Staff Report & Recommendation

Design Review Board

SUBJECT: DRB17-0143

5774 PineTree Drive and 5777 La Gorce Drive – Single Family Home

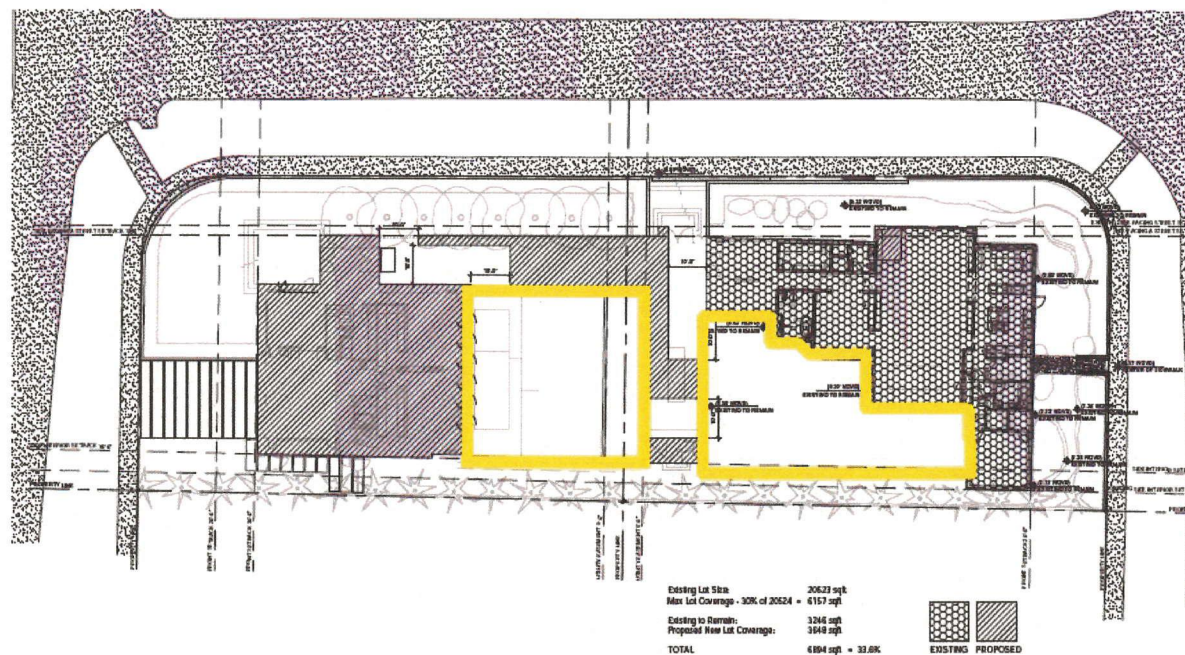
The proposed additions creates an outdoor recreational courtyard between the main two massings of the residence. This yard area is predominantly open to the sky and provides ample private recreational area for the residents. For purposes of calculating lot coverage, internal courtyards, which are open to the sky, but which are substantially enclosed by the structure on three or more sides, must be included towards the lot coverage calculation. The two areas highlighted below illustrate the nearly 4,000SF of outdoor areas that constitute the excessive lot coverage of 55%.

If this 4,000SF of outdoor areas was subtracted out for anyalsis purposes, the applicants would be requesting a lot coverage of 34% which is below the maximum lot coverage allowance for the retention and expansion of existing architecturally significant' pre-1966 homes.
